**MINERALS PROGRAM INSPECTION REPORT**  
**PHONE: (303) 866-3567**

<b>MINE NAME:</b> Boettcher Limestone Quarry	<b>MINE/PROSPECTING ID#:</b> M-1977-348	<b>MINERAL:</b> Limestone (general)	<b>COUNTY:</b> Larimer
<b>INSPECTION TYPE:</b> Monitoring	<b>INSPECTOR(S):</b> Amy Eschberger, Patrick Lennberg, Michael Cunningham, and Russ Means	<b>INSP. DATE:</b> January 30, 2020	<b>INSP. TIME:</b> 10:30
<b>OPERATOR:</b> Holcim (US) Inc.	<b>OPERATOR REPRESENTATIVE:</b> Travis Bennett and Mike Toelle	<b>TYPE OF OPERATION:</b> 112c - Construction Regular Operation	
<b>REASON FOR INSPECTION:</b> Normal I&E Program	<b>BOND CALCULATION TYPE:</b> None	<b>BOND AMOUNT:</b> \$2,518,261.30	
<b>DATE OF COMPLAINT:</b> NA	<b>POST INSP. CONTACTS:</b> None	<b>JOINT INSP. AGENCY:</b> None	
<b>WEATHER:</b> Clear	<b>INSPECTOR'S SIGNATURE:</b> 	<b>SIGNATURE DATE:</b> February 28, 2020

# M1977-348 / Boettcher Limestone Quarry / Holcim (US) Inc. (Image data from 7/17/2019)

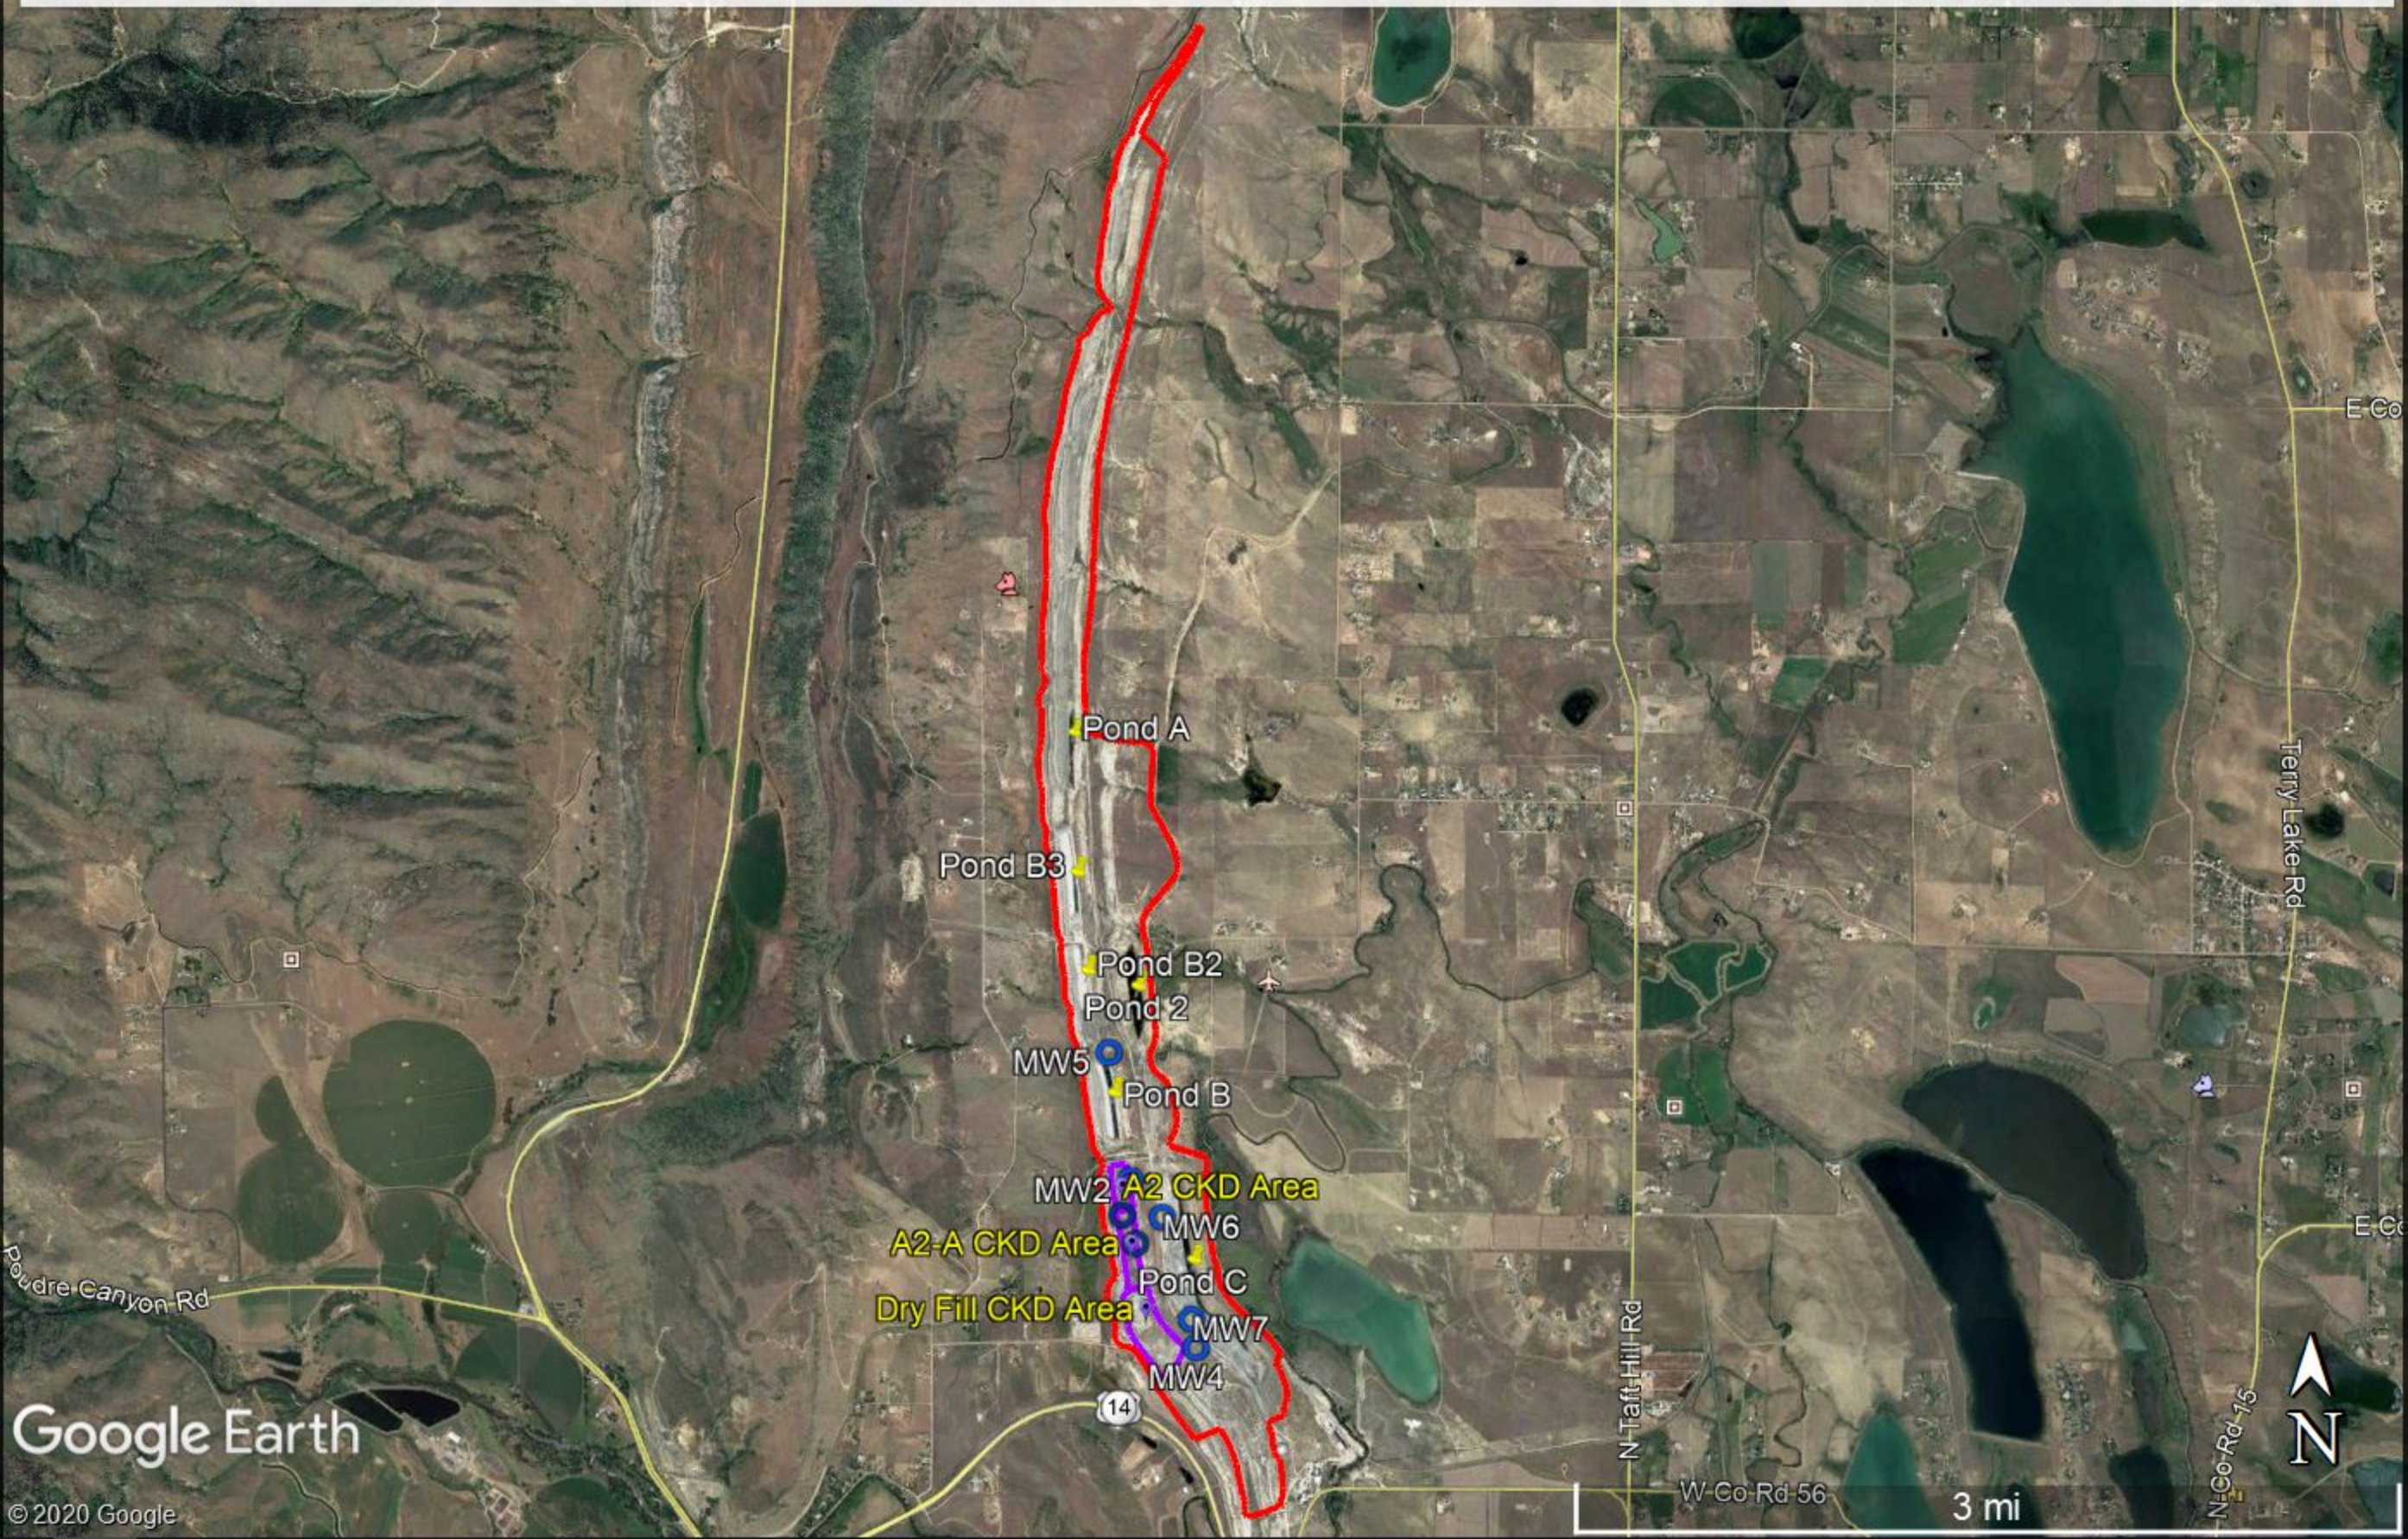
**PROBLEM #1:** The Division has no evidence the operator has a valid well permit, substitute water supply plan, or approved water augmentation plan for the exposed groundwater and/or impounded runoff observed at the site. This is a problem pursuant to C.R.S. 34-32.5-116(4)(h) and Rule 3.1.6(1)(a) which require the operator to comply with applicable Colorado water laws and regulations governing injury to existing water rights.

The Division observed water ponded in three of the pits located along the western edge of the permit area (Ponds A, B3, and B) and in two of the pits located along the eastern edge of the permit area (Ponds 2 and C). The operator estimates the ponded water in the pits to be approximately 15 feet deep. Pond B2 located in the western portion of the permit area was dry during the inspection. The Division of Water Resources (DWR) requires operators to ensure water is not retained on site for more than 72 hours, unless an augmentation plan approved by water court is obtained. An augmentation plan must also be obtained for any exposed groundwater, unless an exemption has been approved by DWR.

**CORRECTIVE ACTIONS:** By the corrective action date, the operator shall demonstrate the operation is in compliance with the Office of the State Engineer (SEO), show evidence the operator is taking measures to bring the site into compliance with the SEO, or backfill the pits to at least two feet above the water surface. If, by the corrective action date, the operator has not submitted the required corrective action, the reclamation bond for the site will need to be re-evaluated to include costs for backfilling the ponded water.

Closer view of southern portion of site where groundwater monitoring wells and CKD disposal areas are located.

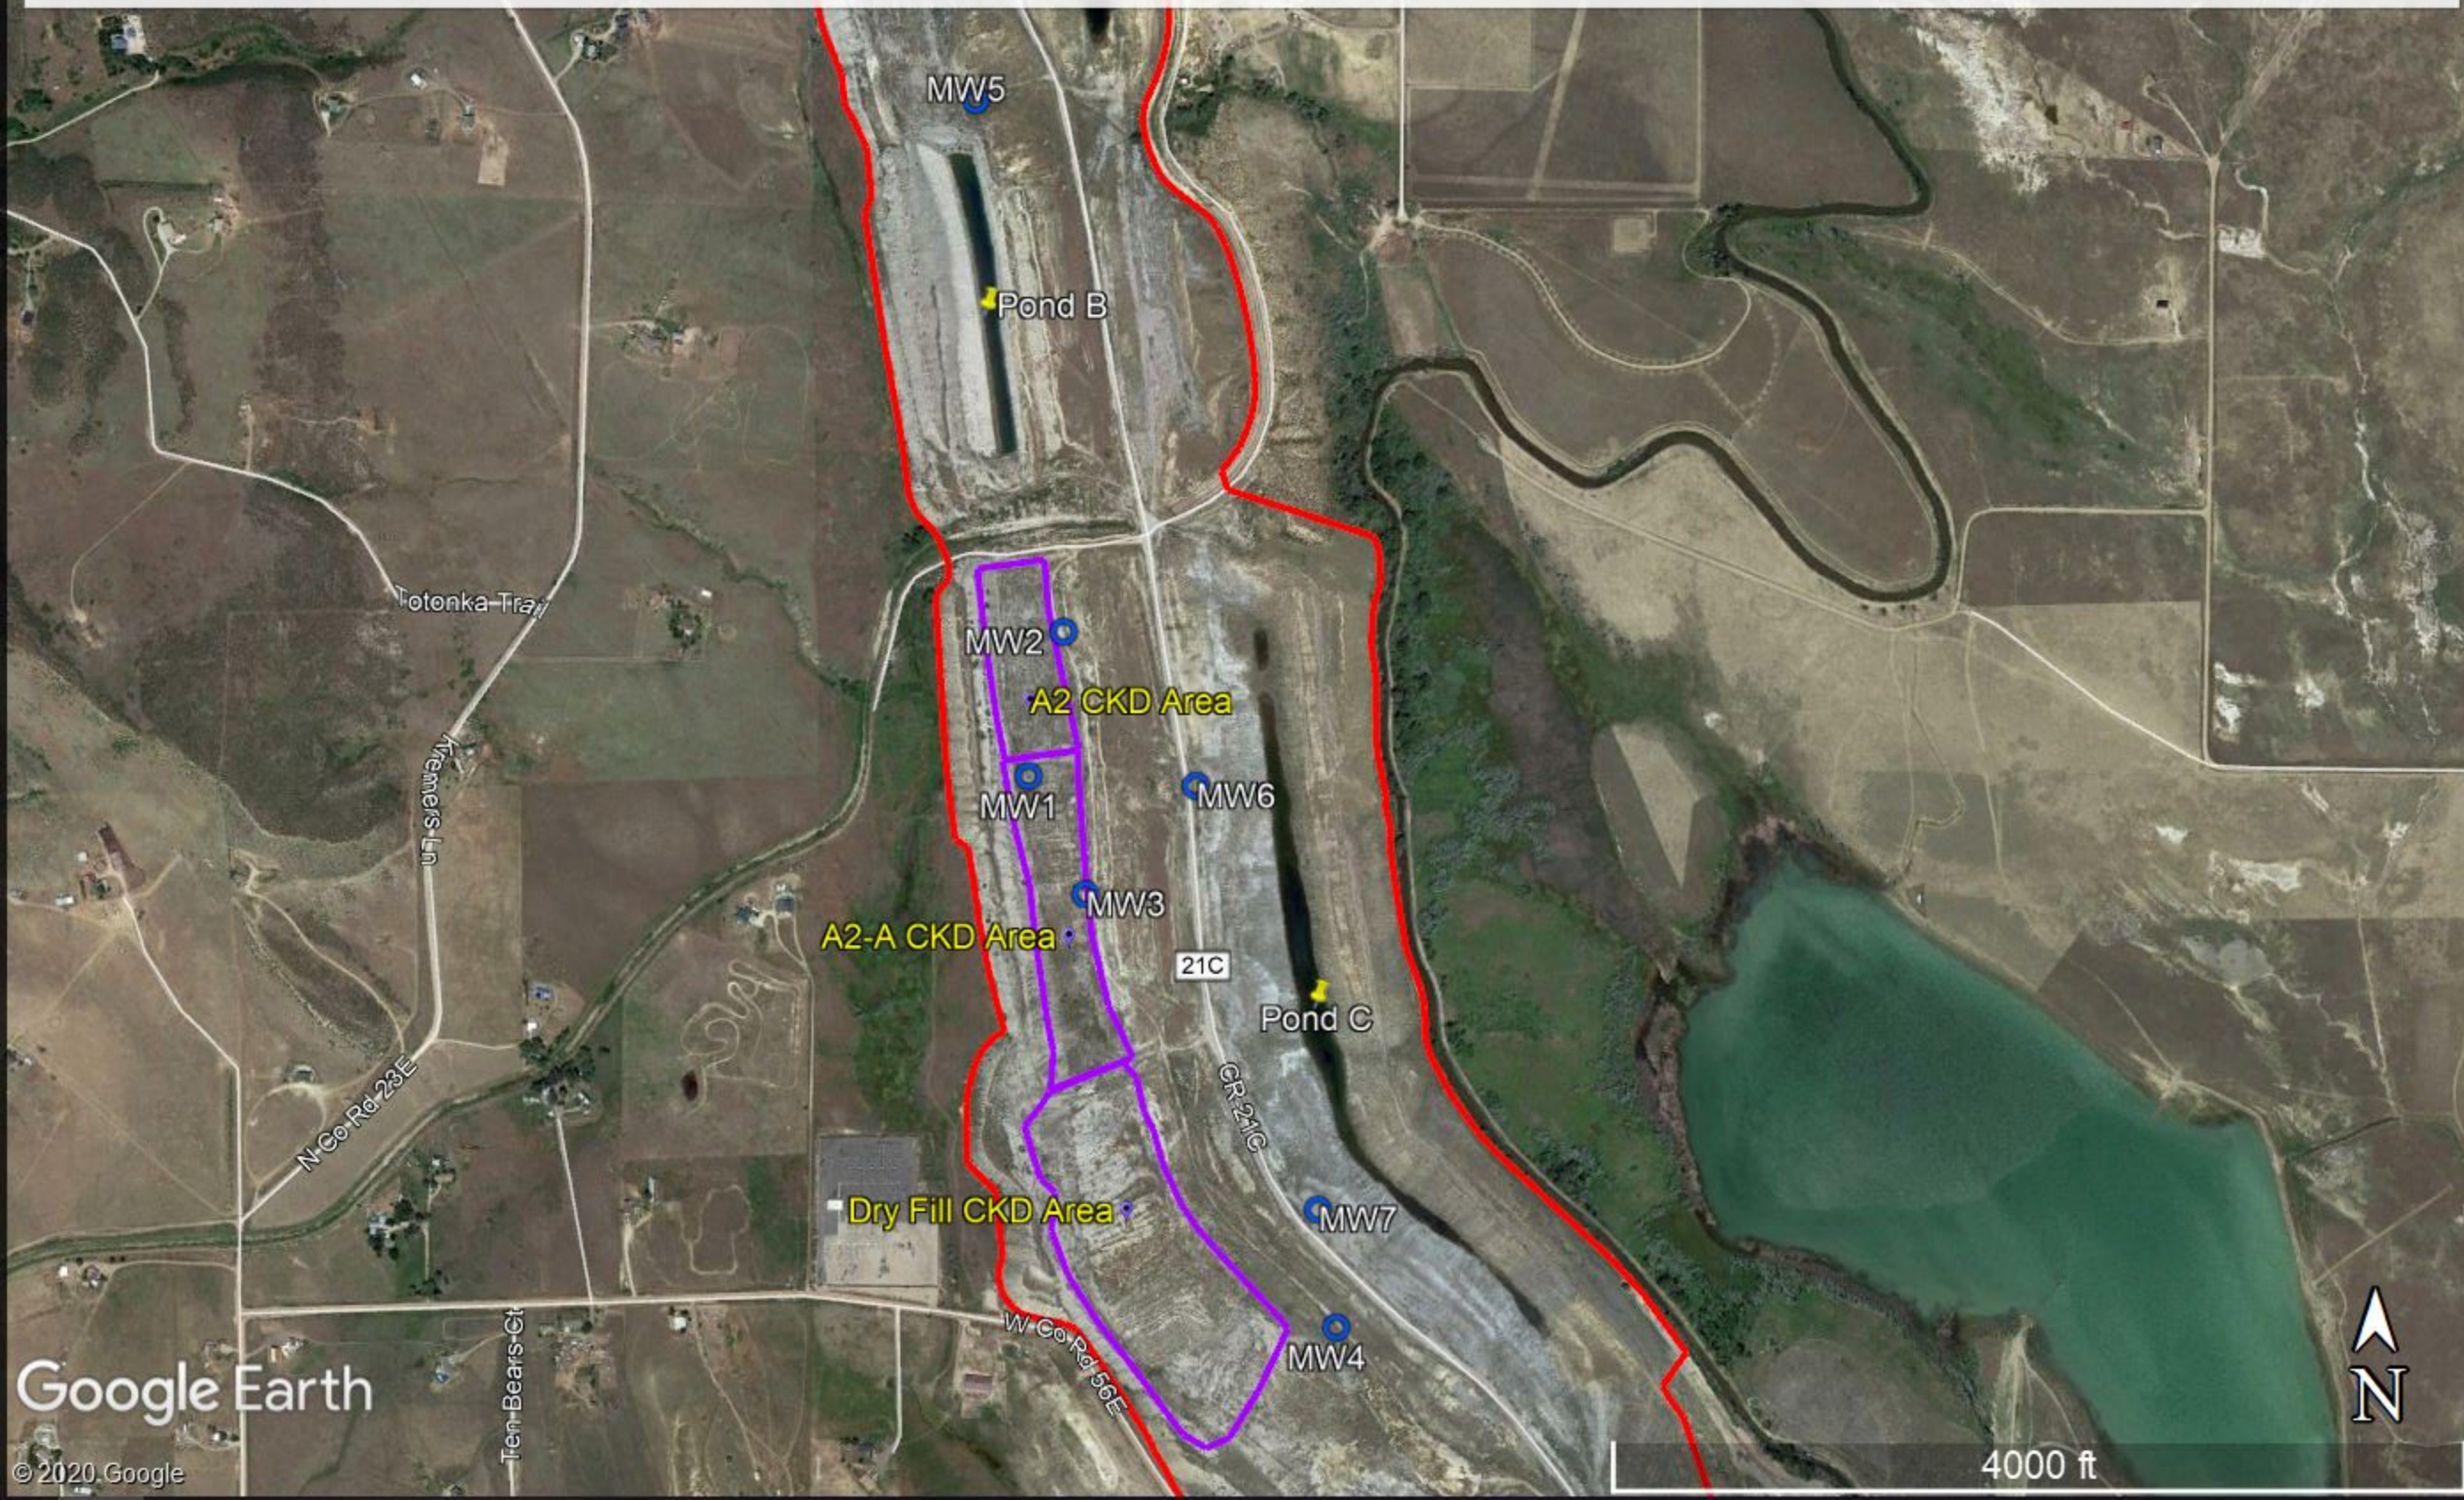
**PROBLEM #2:** The groundwater monitoring data for the site shows several parameters exceeding Table Value Standards set by the Water Quality Control Commission's (WQCC) Regulation No. 41, which apply to this

The operation monitors groundwater at the site from a total of seven monitoring wells (MW-1 – MW-7), with all but one (MW-5) located near or downgradient of the CKD disposal areas in the southern portion of the permit area. MW-5 was installed in overburden outside (and north) of the CKD disposal areas. The Division collected GPS data for all well locations during the inspection (see enclosed Google Earth images of site). All wells were properly secured with padlocks. It should be noted, the concrete apron around well MW-1 is elevated above the ground by approximately 8 inches. Depending on the competence of the surface seal of the well, having the apron raised above the ground surface could allow water to migrate down the casing and into the well. Therefore, the Division recommends the operator install a proper concrete apron around well MW-1.

- 5) The groundwater monitoring program for the site does not include points of compliance or ambient groundwater quality data.
- 6) In order for the Division to evaluate protection afforded groundwater quality and compliance with groundwater standards, point(s) of compliance must be established at the site.

The operator will need to submit a Technical Revision (see enclosed form), with the applicable fee, to revise the groundwater monitoring program to include proposed point(s) of compliance in accordance with Rule 3.1.7(6) and (7) at some distance hydrologically downgradient from the Cement Kiln Dust (CKD) disposal areas. Due to the lack of ambient groundwater quality data for the site required by Rule 3.1.7(b)(viii), the revision shall also include proposed background monitoring well(s) located outside of the CKD disposal areas and screened across

similar lithological units as existing downgradient monitoring wells and the proposed compliance well(s). The information obtained from these wells will be used to evaluate protection afforded groundwater quality and compliance with groundwater standards.
